September 2018  
FL768AB  
NHTSA #18V-250 School Buses  
#18V-378 Non-School Buses  
Transport Canada #18-197

**Subject: FCCC Bus Chassis Battery Cable Interference**

**Models Affected: Freightliner Custom Chassis B2 school bus chassis (Thomas Built Buses Saf-T-Liner C2) and S2C shuttle bus chassis manufactured March 10, 2017, through March 6, 2018.**

**Fig. 1, Incorrect Battery Cable Installation**

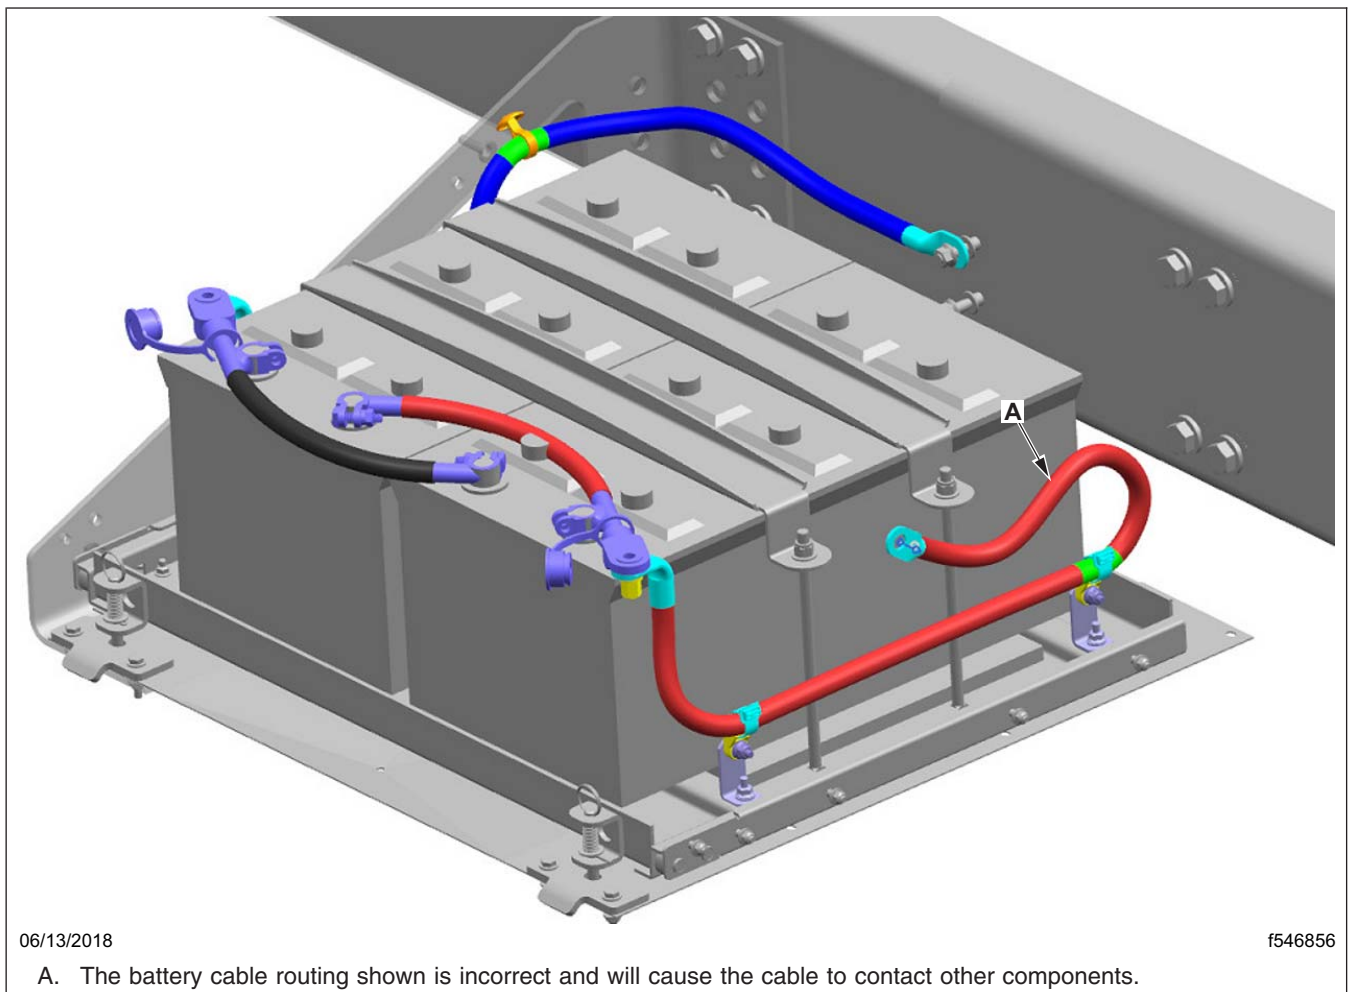
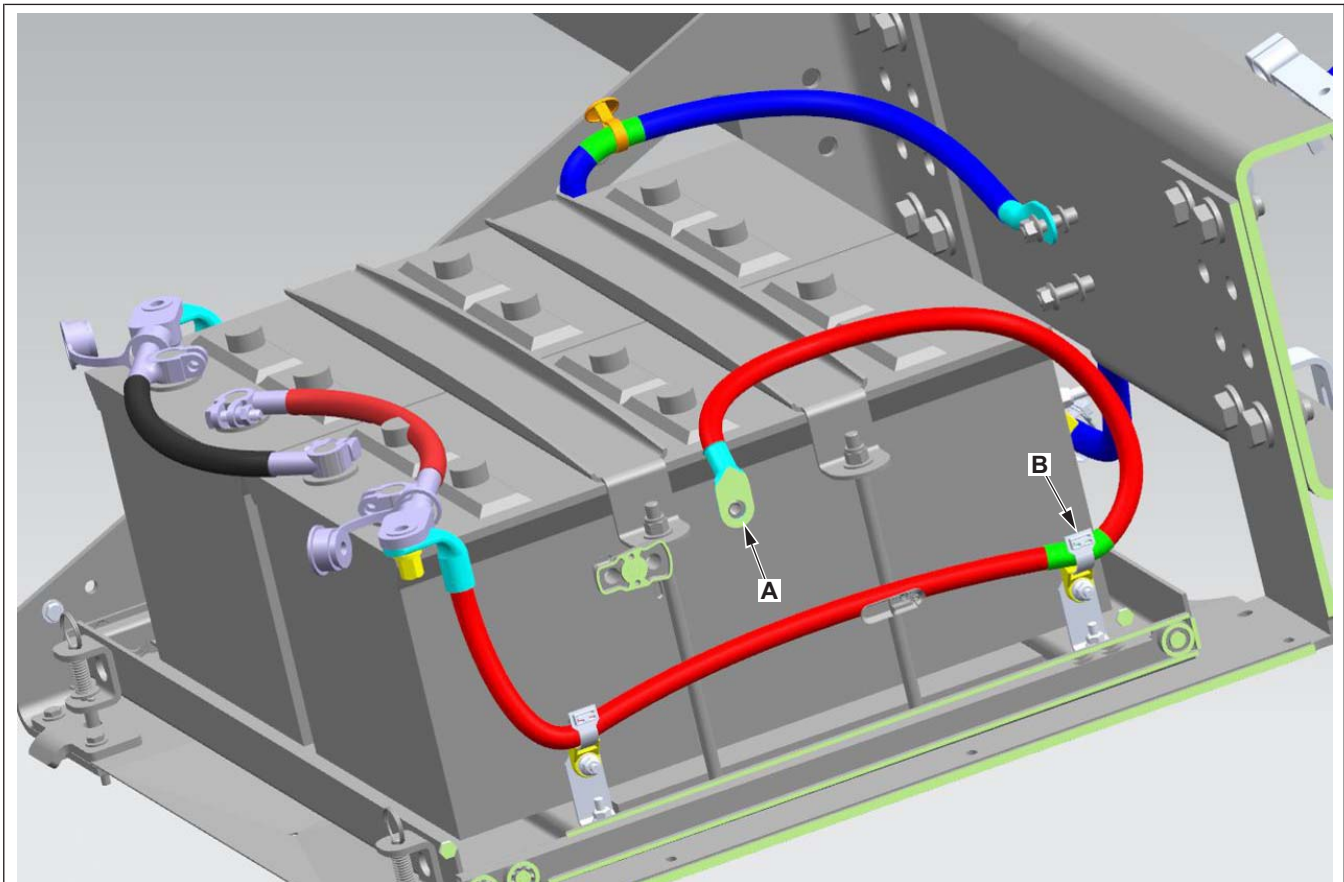
On certain vehicles, a battery power cable may be routed with inadequate clearance between the cable and a battery hold down bracket. This reduced clearance may cause the cable to rub against the hold down bracket, potentially damaging the cable and leading to arcing, which may increase the risk of a fire.

1. Check the base label (Form WAR259) for a completion sticker for FL768 (Form WAR260) indicating this work has been done. For school buses, the base label is usually located above the driver's window. For shuttle buses, it's usually located in the driver's area. If a sticker is present, no work is needed. If there is no sticker, proceed with the next step.
2. Park the vehicle on a level surface, shut down the engine, and set the parking brake. Chock the tires.
3. Inspect the battery cable for correct orientation. There must be a minimum of ½ inch (13 mm) between the cable and the battery hold-down bracket and stud when sliding the battery tray in and out. **Fig. 1** shows an incorrect battery cable installation. **Fig. 2** shows the correct battery cable installation.

- A. Rotate the end of the battery cable to an approximate 11 o'clock position.
- B. Align the tape on the battery cable with the saddle mount.

4. With the battery tray pushed in, use a wrench to loosen the nut on the battery cable at the power distribution module (PDM) stud.
5. Rotate the end of the battery cable as shown in **Fig. 2**, then tighten the nut 26 lbf-ft (35 N-m).

4. With the battery tray pushed in, loosely install the new battery cable on the PDM stud with the nut removed earlier. Route the cable back toward the frame rail, then loop it forward, aligning the tape on the cable with the saddle mount as shown in [Fig. 2, ref. B](#). Rotate the end of the cable to the 11 o'clock position (approximately), ensuring there is ½ inch (13 mm) clearance between the battery cable and the battery hold-down bracket and stud. Tighten the nut 26 lbf·ft (35 N·m).
